1. Schematics Creation
1. Schematics updated to support TPS2590 in place of TPS25910

POWER_PROBE_JACK Project

RevA

JACK Power Path

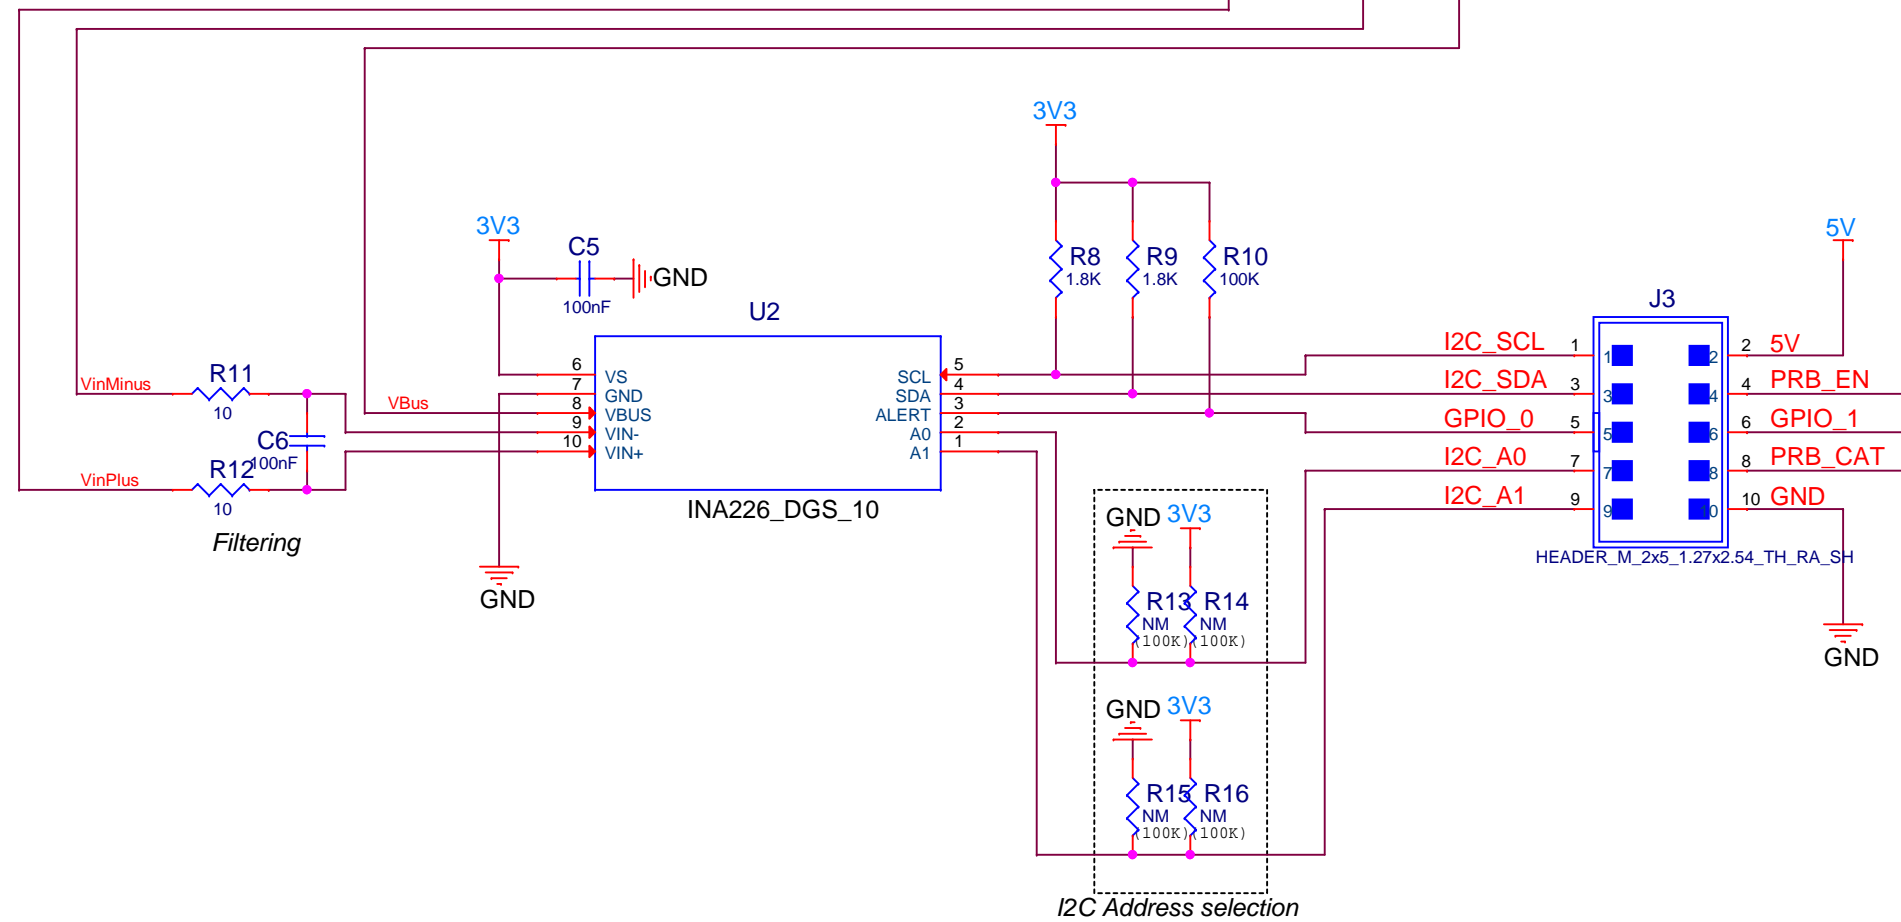
To support TPS2590 in place of TPS25910:
 # Mount R2 0ohm resistor
 # Remove C3
 # Replace R5 0ohm by 33Kohms
 # Replace R7 0ohm by 100nF 0603 capacitor
